NOTICE OF A TYPE II DECISION ON A PROPOSAL IN YOUR NEIGHBORHOOD

CASE FILE NUMBER: LU 19-193115 HRM - SNOWPEAK

Proposal:
The applicant proposes alterations to the existing storefront system to include:

South Elevation

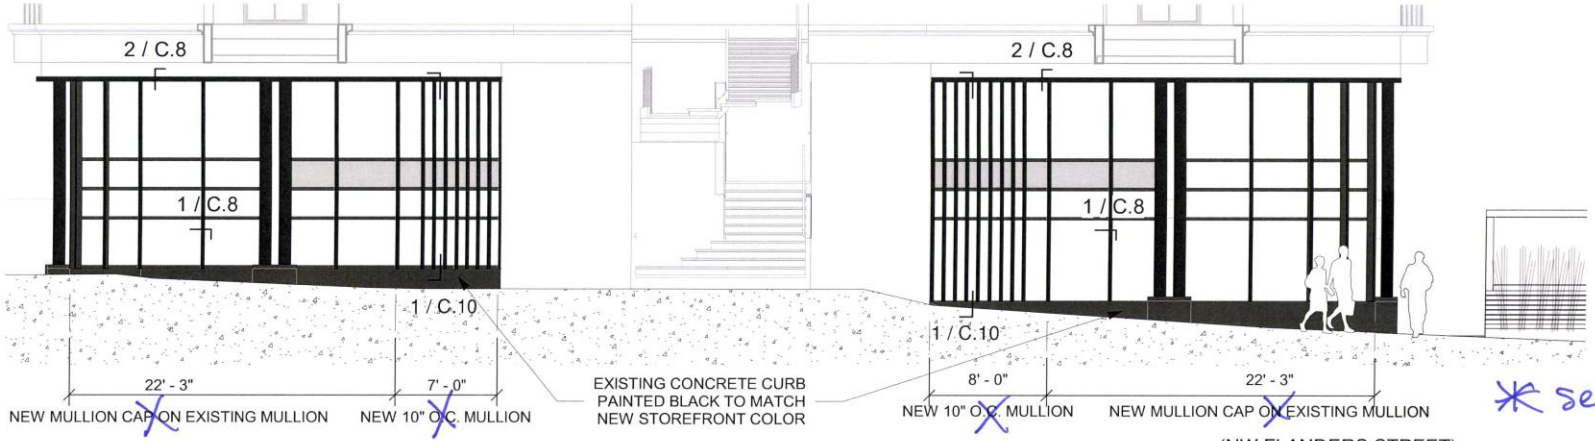
* see Condition D

D. The metal fins shall be removed from the proposal.

West Elevation

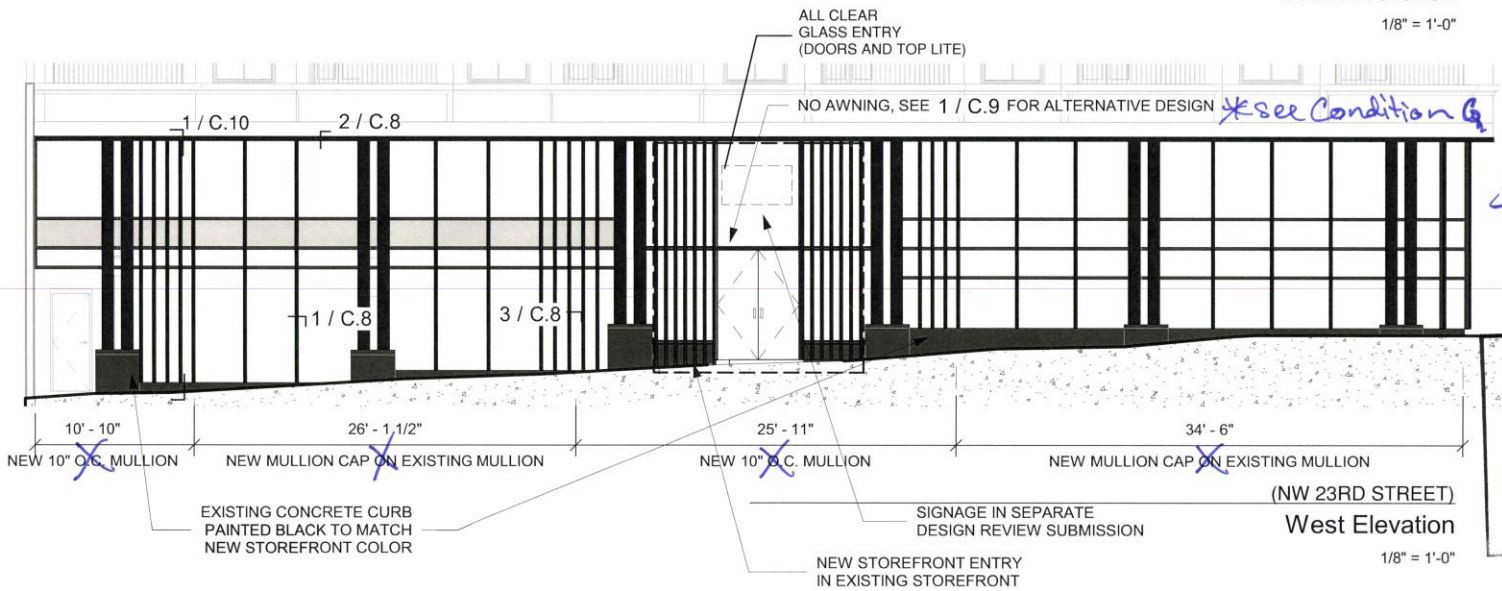
* see Condition G

* See Condition D

G. The proposed metal canopy is required and shall be provided at the west entrance.

South Elevation 2

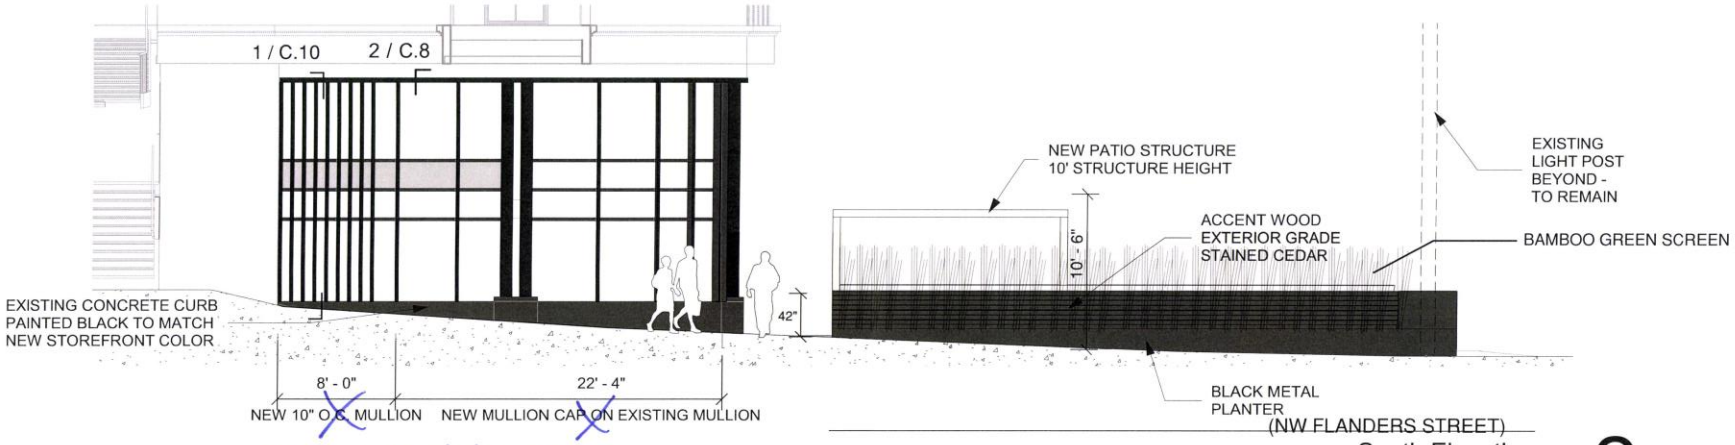
*see Condition D

*see Condition E

E. If retained as part of the proposal, the metal soffits shall extend along the entire underside of the second floor along the west, south, and east façades.
